PROJECT NAME: AZALEAS SKILLED NURSING FACILITY

PROJECT NUMBER: 2025010041

APPLICATION: MAJOR SITE PLAN #32388

AZALIA SKILLED NURSING AND MEMORY CARE FACILITY
MARION COUNTY, FLORIDA
TREE REMOVAL PLAN

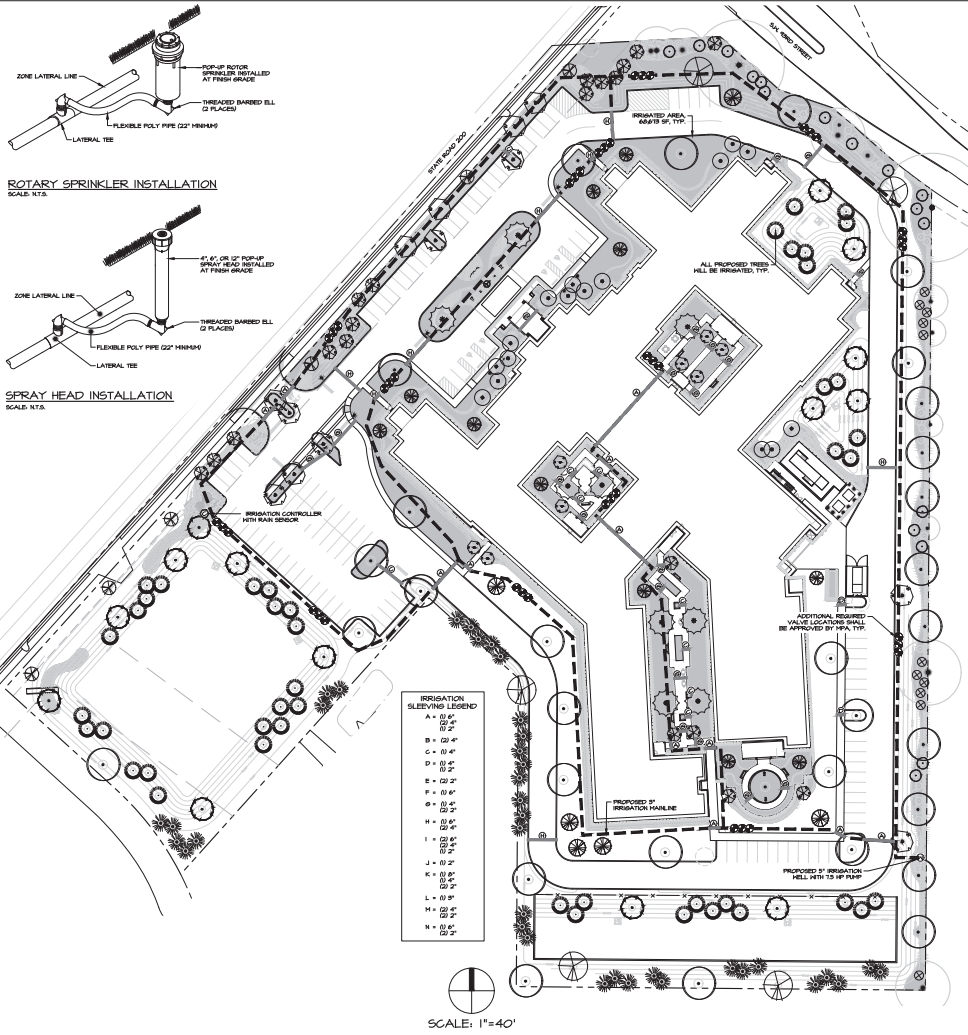
REMARKS: Show tree protection on the plan for each tree to be preserved

REMARKS: Calculation appears to be incorrect - 964" req - 294" preserved= 670" replacement. Providing 626" on site, deficit of 44", not 284". Please verify and correct. Palms cannot count as shade trees

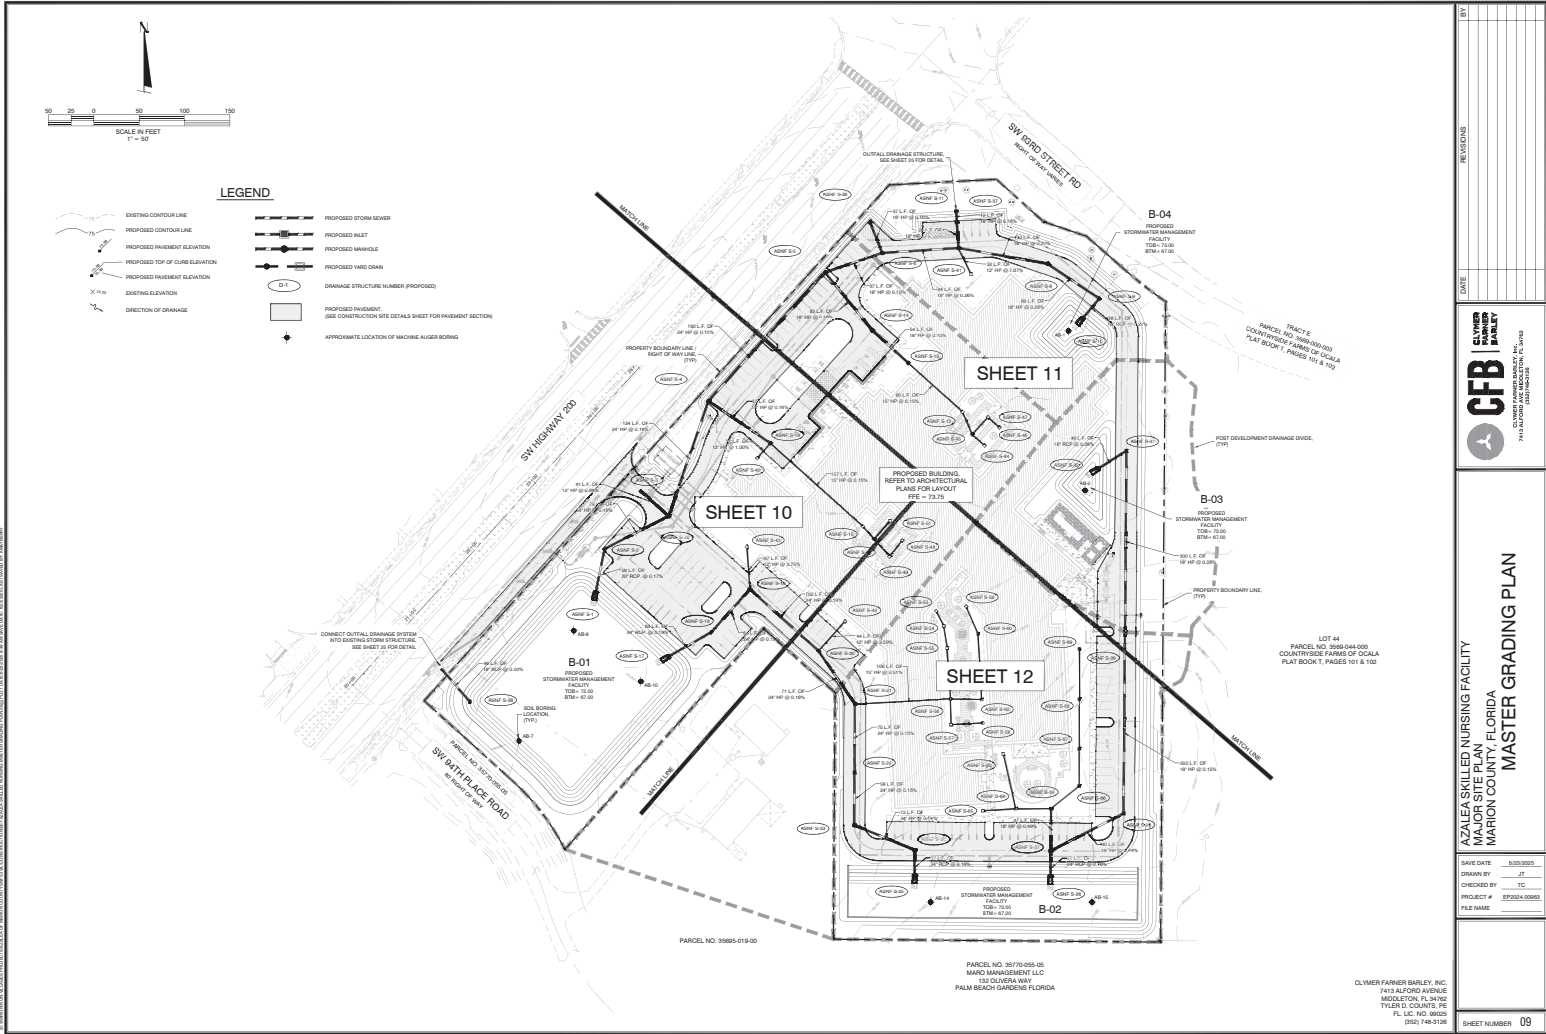
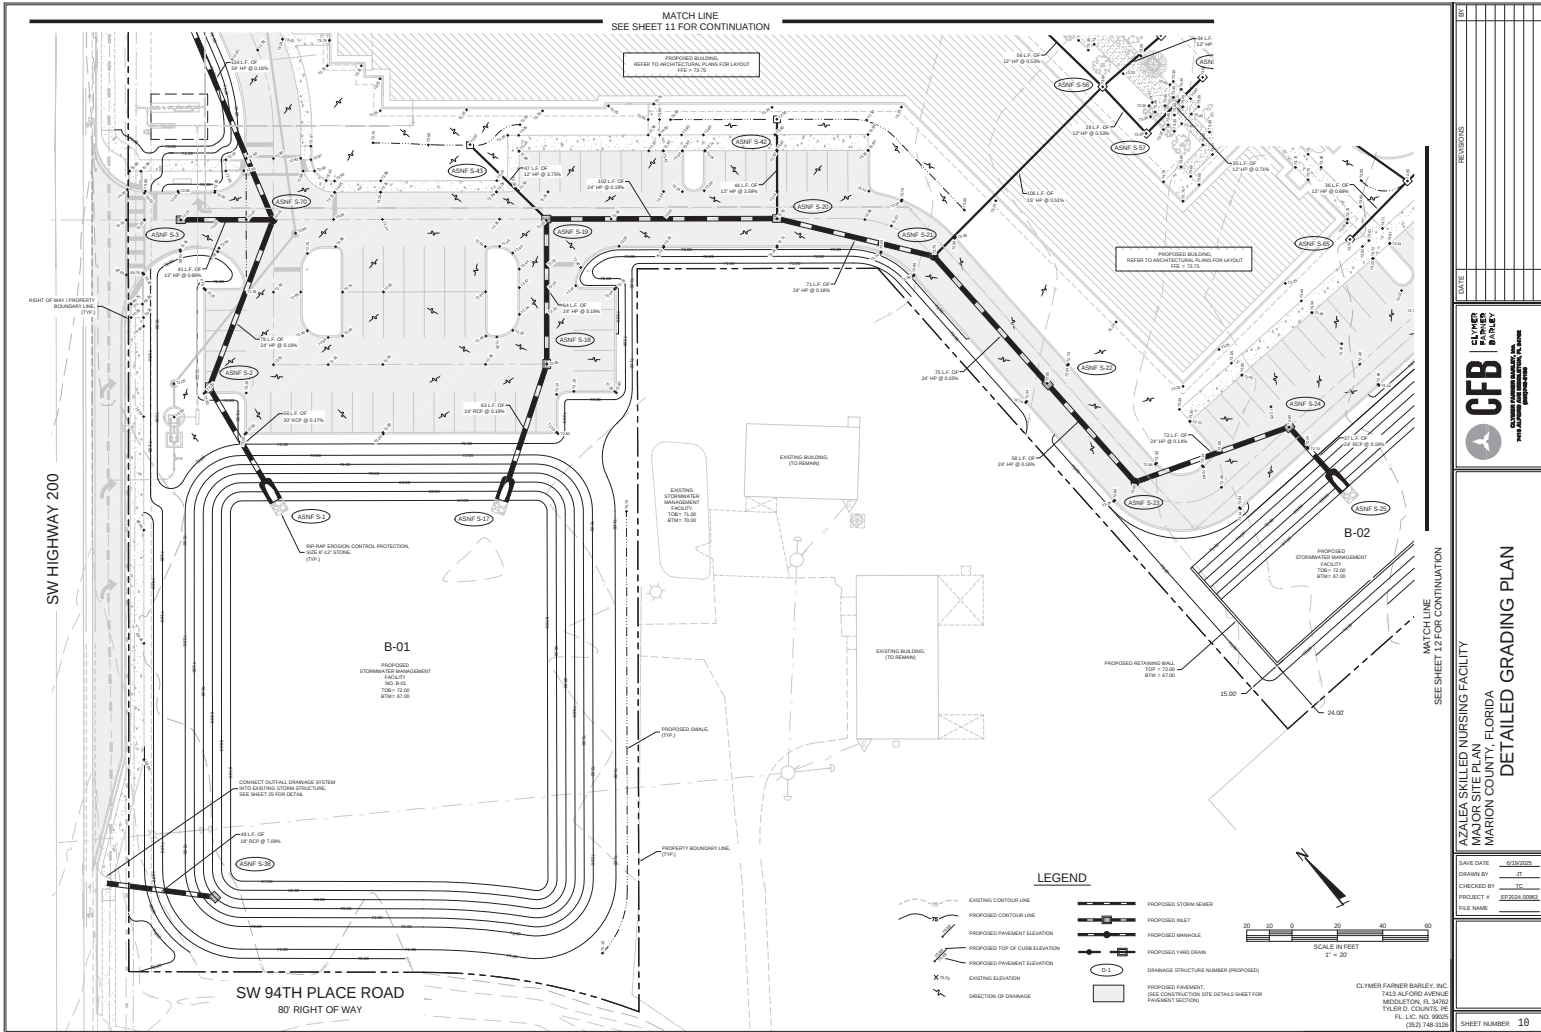
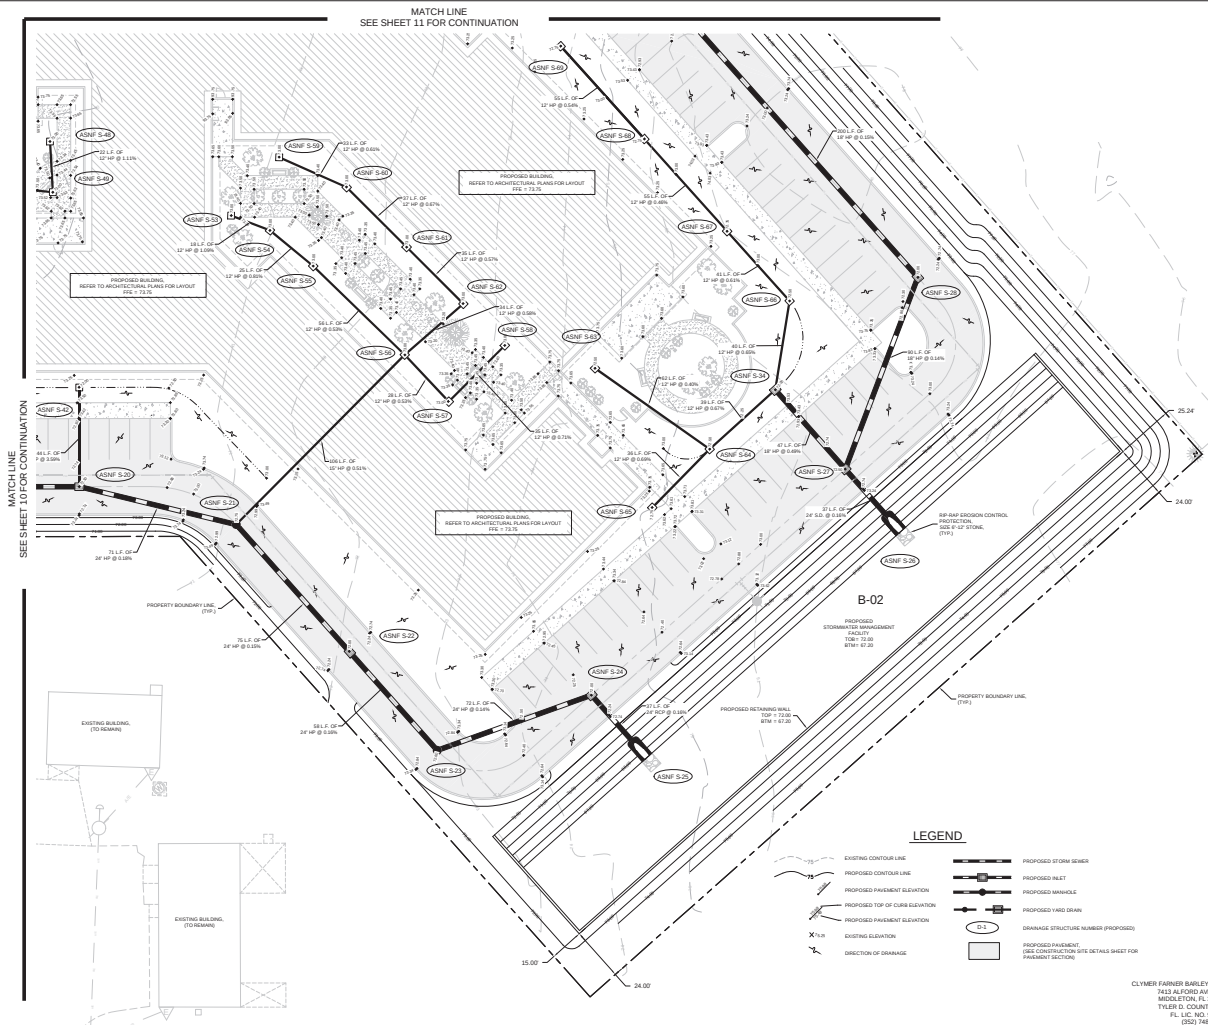
[1] Buffers need to be shown, dimensioned and labeled on the site plan sheets 5 through 8, consistent with the landscape plan. For the Type B buffer along the site's east boundary, specifically label the buffer as a Type B Buffer w/ 6' pillar/panel buffer wall.

[2] The 06-24-25 LS sheet states there should be a 15' Type C buffer along SW 200 Hwy. However, on 06 Detailed Site Plan v2, the space between SW 200 property line and parking shown as 10'. This 10' space seems to extend to sheet 07, but the space is not dimensioned. How will a 15' Type C buffer be provided in this 10' space?
